Access Compliance Report

Public Rights-of-Way

Intersection ID: 53350	Main Street: SAPPHIRE_HILL_LN	Cross Street: LOST_CANYON_WY	Location: NW
ADA ID: 0A1F15212D56	Ramp Type: BlendTrans1	Initial Pass/Fail: Fail	Overall Compliance: No
Severity Score: 1.25			
Codes/Mitigation Info/Possible Solution		Field Measurements/Component Compliance

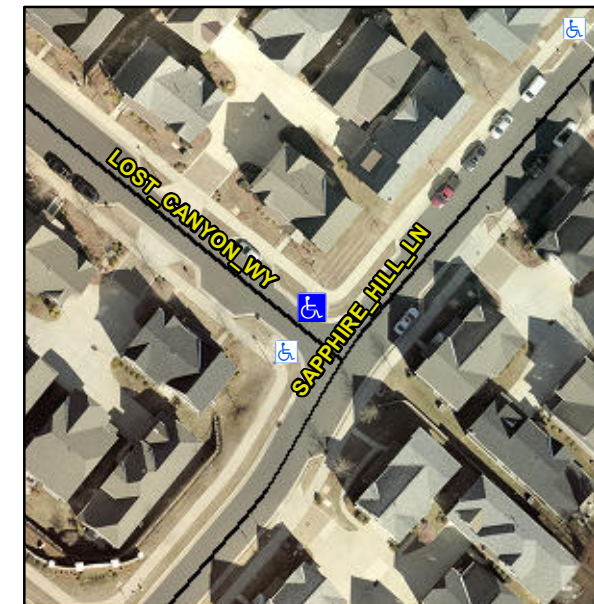
Not Found, R304.5.3

Compliance	Description	Data	Compliance	Description	Data
N/A	Ramp Length (in)	91.0	Yes	BlendTrans Slope (%)	1.2
Yes	Ramp Width (in)	59.0	No	BlendTrans XSlope (%)	3.7
N/A	Flare Type LT	N/A	N/A	Flare Type RT	N/A
N/A	Flare Slope LT (%)	N/A	N/A	Flare Slope RT (%)	N/A
N/A	Flare Traversable LT?	N/A	N/A	Flare Traversable RT?	N/A
N/A	Landing Length (in)	N/A	N/A	DWS Provided?	N/A
N/A	Landing Width (in)	N/A	N/A	DWS Contrast?	N/A
N/A	Landing Slope (%)	N/A	N/A	DWS Length (in)	N/A
N/A	Landing X Slope (%)	N/A	N/A	DWS Full Width?	N/A
N/A	Landing Curb? (Y/N)	N/A	N/A	DWS Offset (in)	N/A
N/A	Shared Landing?	N/A			
N/A	Gutter Ponding?	N/A	N/A	Gutter Slope (%)	N/A
N/A	Gutter Lip Ht (in)	N/A	N/A	Gutter X Slope (%)	N/A
N/A	Painted X Walk1?	No	N/A	Painted X Walk2?	N/A
	X Walk 1 Direction	To SW		X Walk 2 Direction	N/A
	X Walk 1 Width (in)	N/A		X Walk 2 Width (in)	N/A
	X Walk 1 Slope (%)	2.5		X Walk 2 Slope (%)	N/A
	X Walk 1 X Slope (%)	5.1		X Walk 2 X Slope (%)	N/A

N/A	Ramp inside XWalk1?	N/A	N/A	Ramp inside XWalk2?	N/A
	Road Slope (%)	5.1		Clear Space?	N/A
	Road X Slope (%)	2.5	N/A	Clear Space to XWalk (in)	N/A
N/A	Any Obstructions?	N/A	N/A	Storm Grate/Utility Hazard?	N/A
	Obstruction Type			Storm Grate/Utility Type	
		N/A			N/A
			Yes	Surface Condition? (G/P)	Good
			No	Curb Slope (%)	6.4

Remove & Replace Curb Ramp With Two New Directional Ramps or Equivalent.
